## **ADDENDUM NO. 1**

### **RFP NO. 2020-003**

### **Park Improvements – Vinson Park**

January 8, 2020

EXHIBIT A

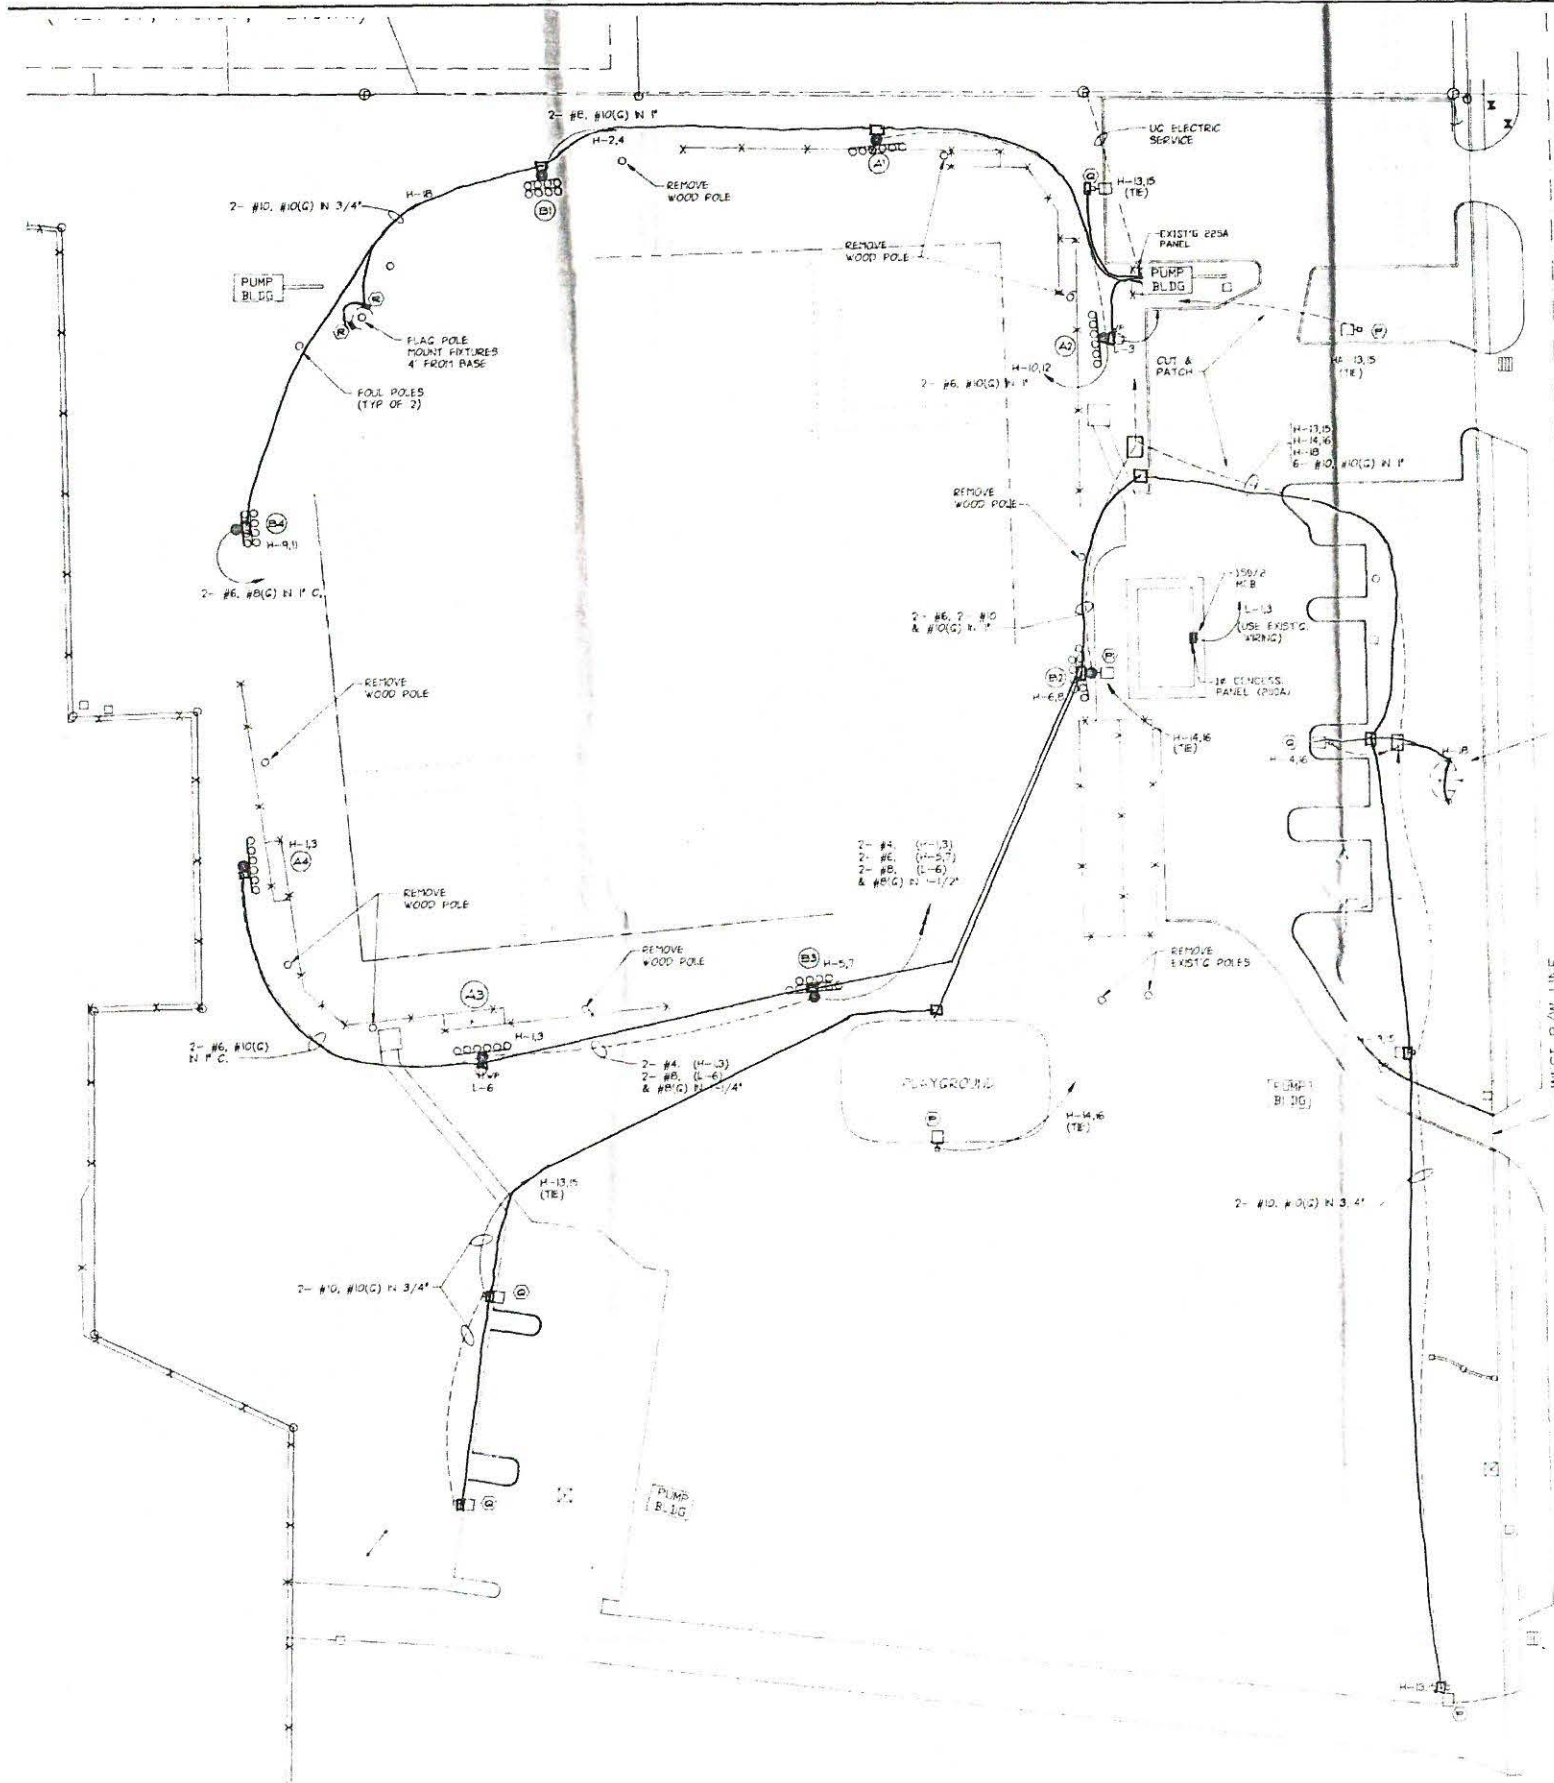
1. We respectfully request an existing survey or site plan for this project.

**ANSWER:** Please see Exhibit A and Exhibit B.
